**ANGEL PLACE
LEVEL 8, 123 PITT STREET
SYDNEY NSW 2000**

RESPONSE TO REQUEST FOR INFORMATION - SSD-8571481

This submission of additional information has been prepared by Urbis on behalf of Technical and Further Education (**TAFE**) NSW in respect of the State Significant Development (**SSD**) application (SSD-8571481) for an educational facility at 2-44 O'Connell Street, Kingswood (**the project**).

Figure 1 Proposed amendment to O’Connell Street access arrangement

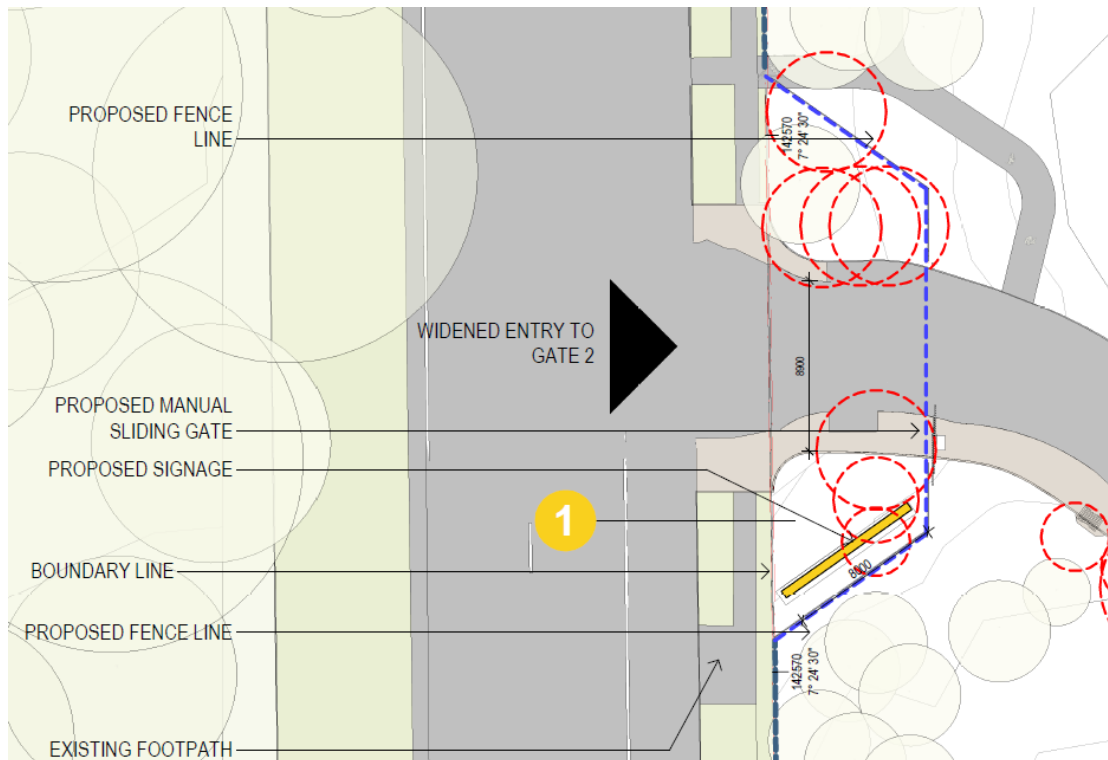
Penrith City Council submission (Item 2) and the Transport for NSW submission (Item 3) have questioned the adequacy of the site access arrangements on O'Connell Street, specifically with regard to the suitability of the width of the driveway. Further analysis was recommended to inform the design arrangement and any local road works necessary to accommodate the development.

| Item | Agency Comment | Proponent Response |
|------|---|---|
| 12 | <p>Swept Path Analysis</p> <p><i>The swept path movements for a 12.5 metre vehicle at O'Connell Street indicate that simultaneous entry/exit cannot be achieved. This can lead to conflict points at the access where 2 opposing vehicles are attempting to use the access at the same time. It is noted that minor works to remove the median (in driveway) and widening of the internal road are proposed. This could extend to the widening at the entrance of the driveway to allow for simultaneous entry exit.</i></p> <p><i>Recommendations are as follows:</i></p> <p><i>The design of the access point should be widened to allow for simultaneous entry/exit movements of the largest vehicle with a passenger vehicle.</i></p> <p><i>However, as O'Connell Street is a Local Road, Council is to determine if the development risks raised by TfNSW is satisfactorily addressed by the applicant. Should the driveway be widened the swept path of the longest vehicle entering and exiting the subject site, shall be in accordance with AUSTRROADS and to the satisfaction of Council</i></p> | <ul style="list-style-type: none"> ▪ As discussed in Section 2.1.2, it is proposed to increase the access point by 1m from 7.9m to provide a total width of 8.9m. ▪ The amended access driveway has been designed in accordance with AS2890.1 (2004) and AS2890.2 (2018), as Austroads Guidelines are not applicable due to the driveway's location on private land. ▪ As illustrated in the revised swept paths appended to the Traffic Impact Assessment (Attachment D), the widened driveway will accommodate the largest size vehicle (12.5m heavy rigid vehicle) passing a B99 design vehicle at the site boundary. |

In response to concerns raised regarding the adequacy of the western access point on O'Connell Street, it is proposed to seek consent for an increase to the width of the driveway access point as illustrated in the revised Architectural Plans (**Attachment B**). It is proposed to increase the access point by 1m to increase the existing width from 7.9m to a total width of 8.9m. The amended access driveway has been designed in accordance with AS2890.1 (2004) and AS2890.2 (2018), as Austroads Guidelines are not applicable due to the driveway's location on private land. The amendments will require tree removal, as discussed further in **Section 2.2**.

As illustrated in the revised swept paths appended to the Traffic Impact Assessment (**Attachment D**), the widened driveway will accommodate the largest size vehicle (12.5m heavy rigid vehicle) passing a B99 design vehicle at the site boundary. It is noted this scenario will not be frequent, as heavy rigid vehicles are only anticipated to access the site once every 2 weeks, arriving and departing outside of peak times. It is further noted the results of SIDRA modelling indicate the access driveway will operate at a Level of Service A, and that there will be no impact on the sight distances as a result of the
